IMPORTANT SAFETY RECALL -

Safety Recall Notice 18V-520

Terex Utilities**SAFETY NOTICE****SN-665-18**

SUBJECT: *One Piece Kelly Bar***Issue:**

Figure 2

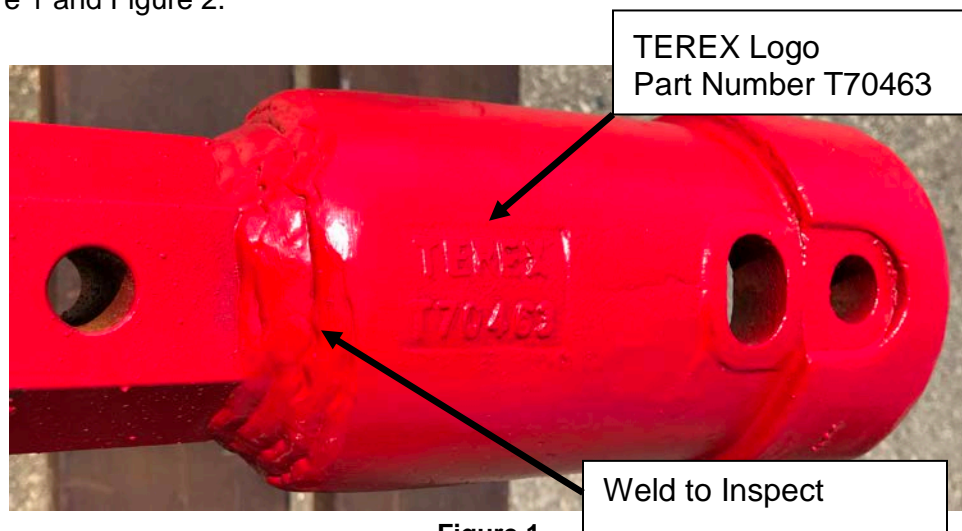
1. Inspect the digger drive kelly bar to determine if this bulletin applies to your equipment.
 - a. This bulletin applies to one piece kelly bars that have a digger drive coupler welded to the hex shaft and the coupler is marked with TEREX logo and part number T70463 as shown in Figure 1 and Figure 2.

2. One piece kelly bars, where this bulletin applies, must have the weld joint between the hex shaft and digger drive coupler inspected for cracks.
 - a. If a crack is found in the weld joint:

- i. Immediately remove the kelly bar from service.
 - ii. Contact your nearest TEREX Utilities dealer as shown on the web site, terexutilities.com; call TEREX Utilities Warranty at 1-844-837-3948 or by email at utilities.warranty@terex.com to arrange for a replacement.

- iii. Send a picture, similar to figure 1, of the suspect kelly bar to Terex warranty at utilities.warranty@terex.com. If the bar is affected, a replacement will be shipped. Include the digger derrick model and serial number with your email.

- b. If no cracks are found in the weld joint:
 - i. The kelly bar may continue to be used following the continued use instructions detailed in this bulletin.

Figure 3

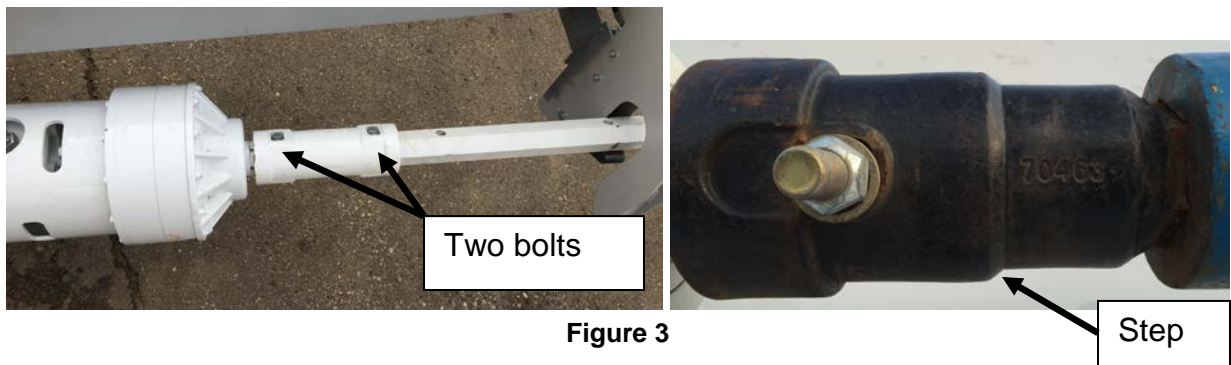
- b. This bulletin does not apply to kelly bar assemblies that have a digger drive coupler bolted to both the digger drive and the hex shaft or welded couplers with a step and no "TEREX T70463" logo cast into the coupler material as shown in Figure 3.
